10COPLEY TOWNSHIP
 ARCHITECTURAL REVIEW BOARD
 JACOBY ROAD PARCELS 1501734,
 1501735, 1503826
 RESIDENTIAL CONSERVATION DEVELOPMENT
 STAFF REPORT*

November 1, 2021

<p>*THIS IS A WORKING DOCUMENT</p> <p>PROJECT: Jacoby Road Rezoning Residential Conservation Development (R-CD) Parcels 1501734, 1501735, 1503826 (1625 Sunnyacres Road)</p>	<p>APPLICATION TYPE: Jacoby Road R-CD-General Development Plan; Final Development Plan; Variance Application;</p> <p>Submitted: 10/12/2021</p> <p>Final Development Plan Approved with Conditions: 8/1/2022</p> <p>Variance Review Requested: 7/5/2022</p> <p>Public Hearing Opened: 8/10/2022</p> <p>Plan Updates: 10/26/2021: CED Comments; SSWCD Comments; 11/1/2021: ORAM, Tree Survey Summary Letter; 11/12/2021 ARB Site Visit; 3/25/2022 SCE Traffic Study Approved; Landscape Plan Submitted; Sewer Capacity Study Approved; 6/15/2022 Jacoby Road Neighborhood Meeting; 6/23/2022 Development Plan Checklist, Tree Preservation Plan Stem Inventory, Variance Review; 6/27/2022 Conservation Easement, ARB Motions for Consideration, SCPH Comment; 6/28/2022 Per the applicant variance review; 6/29/2022 Public Comment Letter from Spring Garden Waldorf School; 7/1/2022 Pride O

WETLAND A

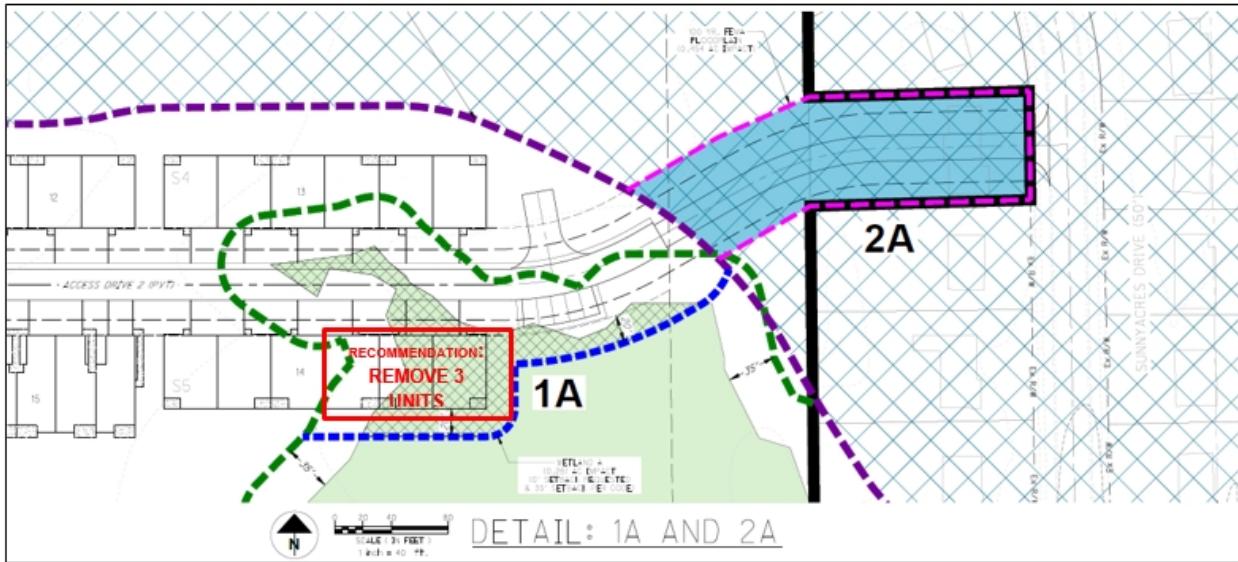
1 A (WETLAND A): The applicant is seeking approval to remove 0.261 acre of wetland for the construction of 3 units and installation of roadway and a 0' from the identified wetland.

ARB RECOMMENDATION: Disapproval. Eliminate identified units to avoid wetland removal and maintain a wetland setback. If the Board of Zoning Appeals should approve the variance, the ARB recommends that a Preliminary Drainage Plan showing no upstream or downstream impacts be required.

Staff concurs with the recommendation of the Architectural Review Board. If the BZA should approve, Staff recommends the BZA require applicant to complete a Hydraulic and Hydrologic Study showing no upstream or downstream impacts as a result of the proposed project.

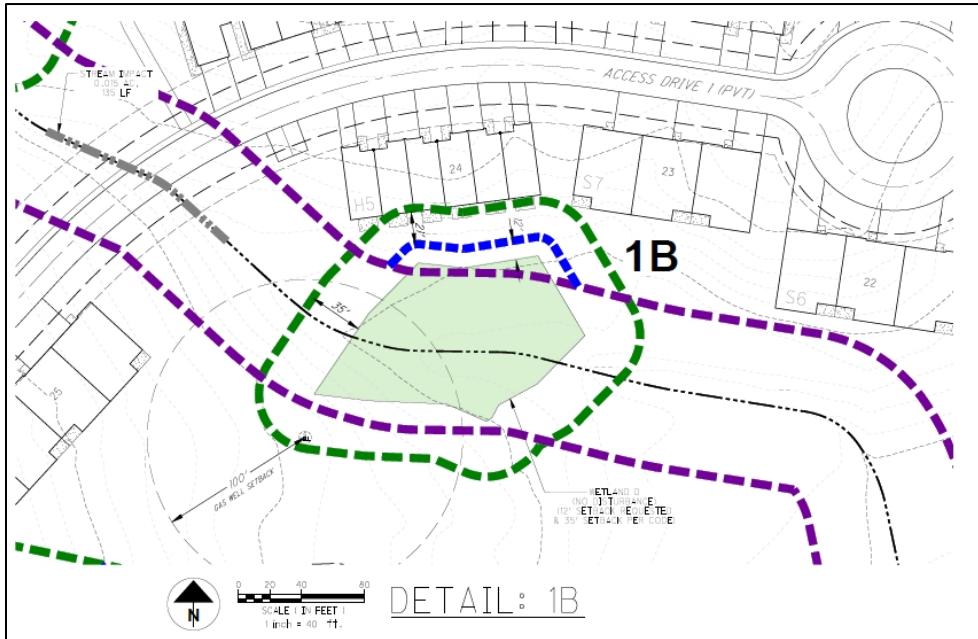
2 A (WETLAND A): The applicant is seeking approval to remove an existing home and construct a roadway for secondary ingress/egress inside of .454 acre of identified floodplain.

ARB RECOMMENDATION: Approval conditioned upon submission of a Preliminary Drainage Plan showing no upstream or downstream impacts as a result of the variance. Secondary ingress/egress is required for Fire/Safety measures. There is an existing impervious structure (home) which will be removed and replaced with a roadway. Additionally, roadway and parking area inside of the identified area (0.454 acre) to be comprised of pervious surface approved by fire and safety.

WETLAND E

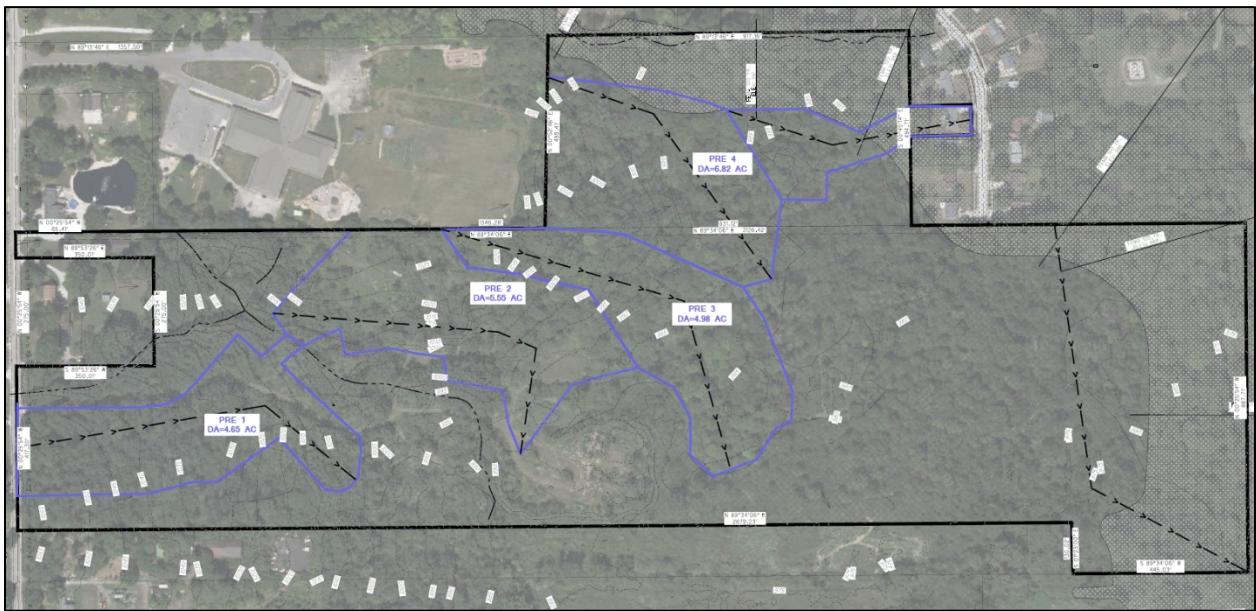
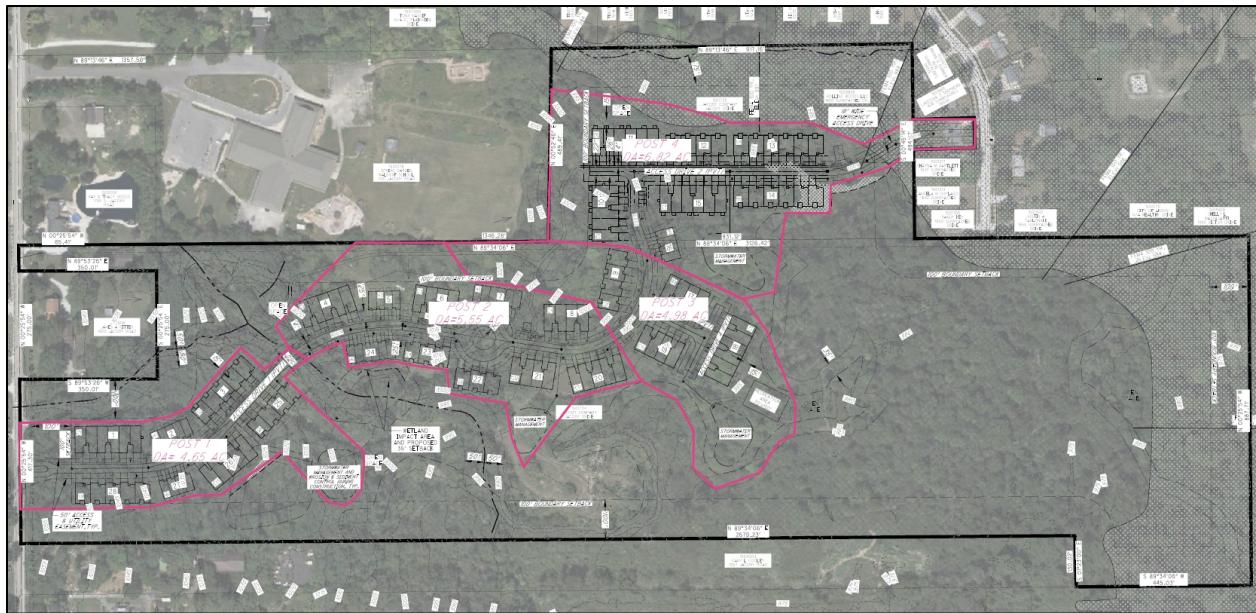
1C (WETLAND E) Applicant is seeking relief from the required 35' wetland setback. The applicant is seeking approval to maintain a 0' setback from the wetland. Applicant is seeking approval to remove 0.027 acre of identified wetland.

ARB RECOMMENDATION: Disapproval. Eliminate identified units to avoid wetland removal and maintain a wetland setback. If the Board of Zoning Appeals should approve the variance, the ARB recommends that a Preliminary Drainage Plan showing no upstream or downstream impacts be required.

Staff concurs with the recommendation of the Architectural Review Board. If the BZA approves, staff recommends the BZA require applicant to complete a Hydraulic and Hydrologic Study showing no upstream or downstream impacts as a result of the proposed project.

DRAINAGE MAP

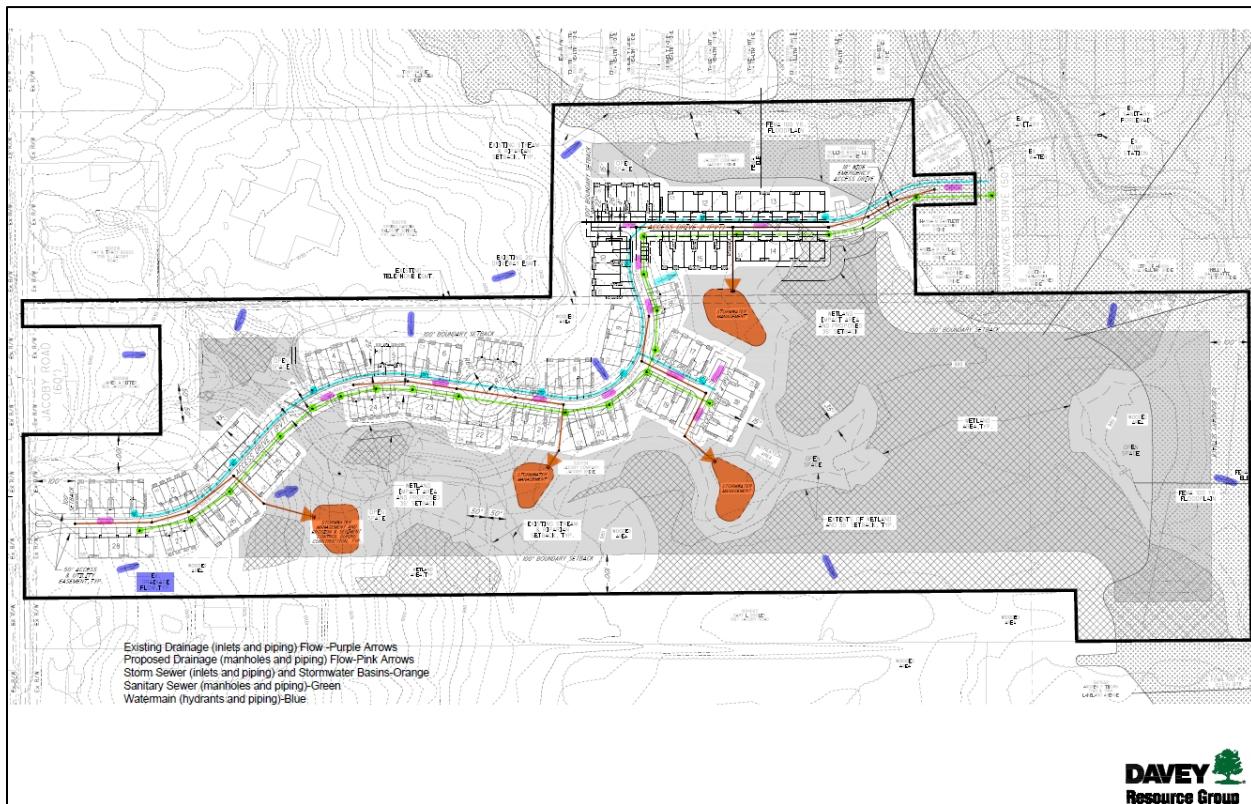
The applicant has provided a drainage map which accounts for the four identified flow areas within the Critical Storm Calculations.
